UNITED STATES PATENT AND TRADEMARK OFFICE

Office Action Summary

10/762,228

DETAILED ACTION

Diagram A - Annotated Figure 3 of Croft

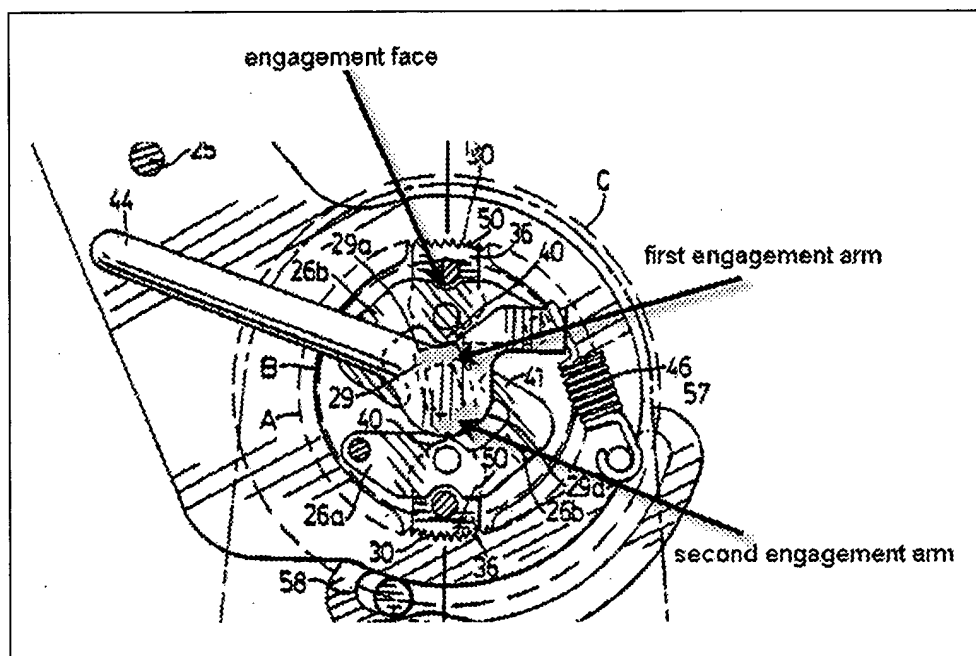
Croft discloses a recliner assembly that includes all the limitations recited in claims 1-3, 6-11, 18, and 22-25. Croft shows a recliner assembly having a first housing plate 33 (see Fig. 2), a second housing plate 23 rotatably support by the first housing plate, first and second pawls 36 that are each movable between a locked position engaging the second housing plate to prohibit rotation of the second housing plate relative to the first housing plate and an unlocked position disengaged from the second

housing plate to enable rotation of the second housing plate relative to the first housing plate, first and second locking cams 26 that are each rotatably supported by the first housing plate, a main cam 29 rotatably supported by the first housing plate, a biasing member 46 acting on the main cam to bias the main cam into engagement with the first locking cam to thereby urge the first pawl into the locked position, an engagement face (see Diagram A below) of the first locking cam that is formed at an angular relationship with the first pawl, first and second engagement arms/extensions (see Diagram A below) of the main cam, a gap disposed between the first and second pawls and the main cam when the first and second pawls are in the locked position, and first and second arms 42,43 of the first pawl with a recess formed therebetween wherein the recliner assembly is supported by a seat bottom and back configuration, the first pawl is operable to apply a primary force to the second housing plate in a locked position with a first force component normal to the engagement of the pawl and the second housing plate and a second force component perpendicular to the first force component, the locking cams are operable to engage the pawls to urge the pawls into the locked position in response to rotation of the main cam, the main cam is operable to selectively rotate the first locking cam into engagement with the first pawl to urge the first pawl into the locked position, the engagement face is operable to selectively receive the first pawl and to apply the primary force to the first pawl at an angle between 14-22 degrees, the first engagement arm of the main cam is in contact with the first pawl to selectively toggle the pawl between the locked and unlocked positions and the second engagement arm is positioned at a predetermined distance from the first pawl when the

first pawl is in the locked position, the gap is operable to allow interaction (via the locking cams) between the first and second pawls and the main cam to further lock the first housing plate to the second housing plate when a predetermined load is applied to the seat bottom or the seat back, the first locking cam is operable to engage the first arm of the first pawl to urge the first pawl into the locked position, and the second arm/extension of the locking cam is spaced a distance from the second arm of the first pawl when the first pawl is in the locked position.
